UNITED STATES PATENT AND TRADEMARK OFFICE

APPLICATION NO.	FILING DATE	FIRST NAMED INVENTOR	ATTORNEY DOCKET NO.	CONFIRMATION NO.
09/989,271	11/20/2001	Michael C. Smyk	FCI-2632/C3069	9590
48580	7590	11/18/2005	EXAMINER	
WOODCOCK WASHBURN, LLP ONE LIBERTY PLACE - 46TH FLOOR PHILADELPHIA, PA 19103			HARVEY, JAMES R	
			ART UNIT	PAPER NUMBER
			2833

Office Action Summary	Application No.	Applicant(s)	
	09/989,271	SMYK, MICHAEL C.	
	Examiner	Art Unit	
	James R. Harvey	2833

DETAILED ACTION

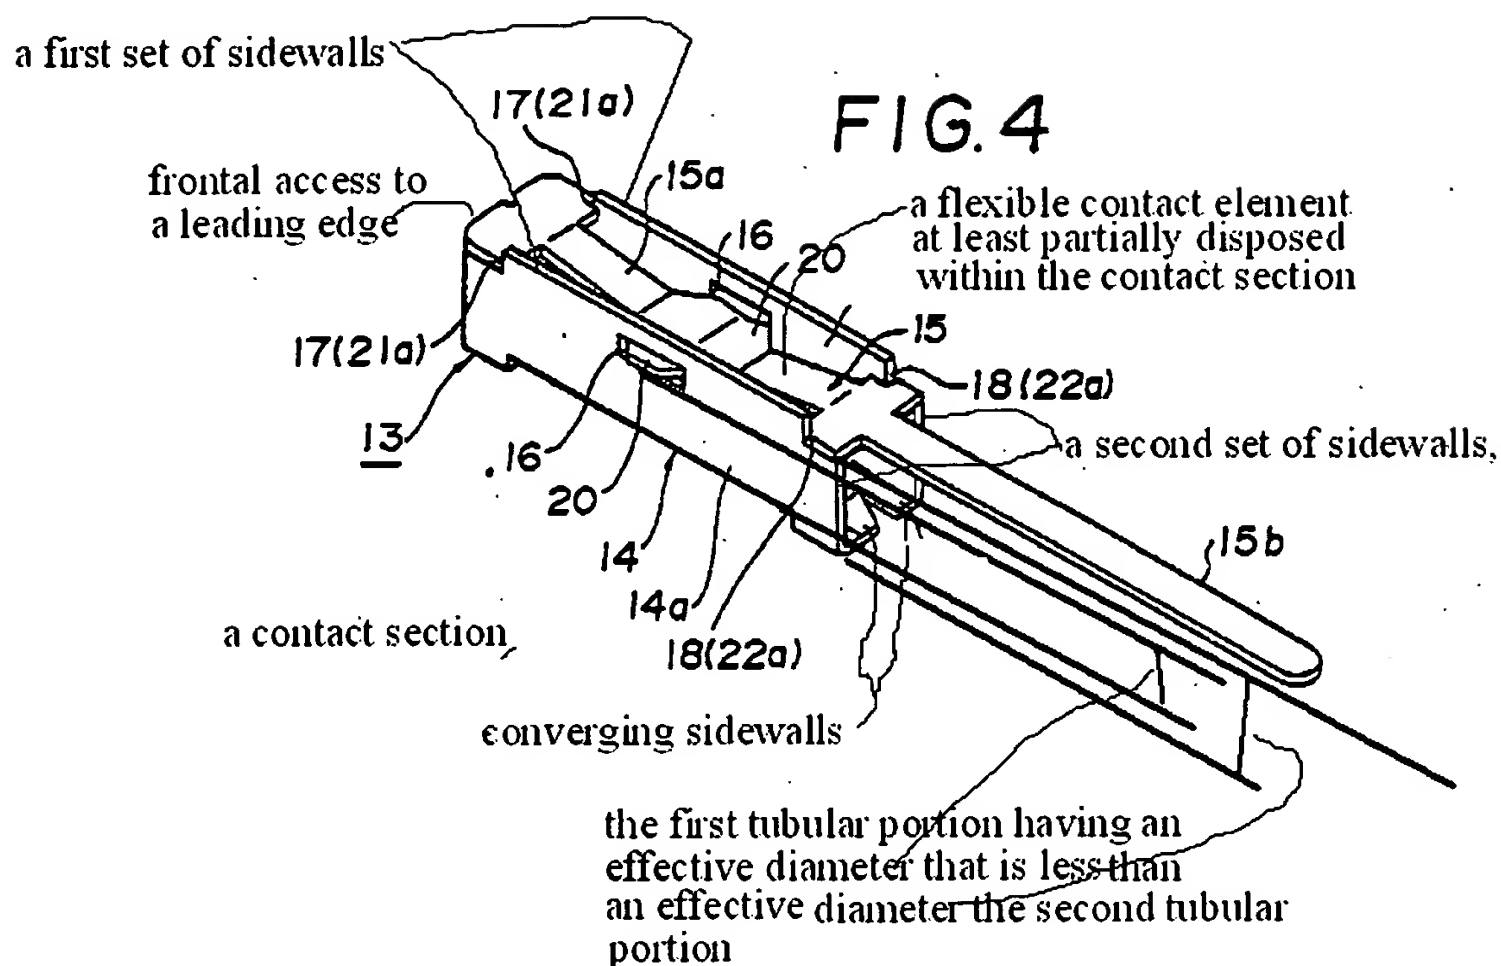
-- In reference to Claim(s) 45, Shima shows (see examiner's figure)

-- In reference to Claim(s) 46, Shima shows (see examiner's figure) the flexible contact element includes a leading edge (see examiner's figure) that is positioned outside of the contact section.

-- In reference to Claim(s) 47, Shima shows (see examiner's figure) the flexible contact element includes a leading edge, and wherein the female electrical terminal is devoid of any structure prohibiting frontal access to the flexible contact element leading edge.

-- In reference to Claim(s) 50, Shima shows (see examiner's figure)

an opening is defined at an interface between the first tubular portion and the second tubular portion; and wherein a portion of the flexible contact element extends into the opening.

-- In reference to Claim(s) 54, Shima shows (see examiner's figure)

a contact section including a set of converging sidewalls that define an insertion pathway for a complementary male terminal,' the insertion pathway having a diameter that is smaller than a tubular portion that is proximate the set of converging sidewalls', and

a flexible contact element partially disposed within the contact section in a non-fixedly secured manner so that opposing ends of the flexible contact element are free. for urging a complementary male terminal into engagement with a contact section bottom wall;

wherein the female electrical terminal is devoid of any structure prohibiting frontal access to a leading edge of the flexible contact element, and

wherein the flexible contact element does not extend into the set of converging sidewalls.
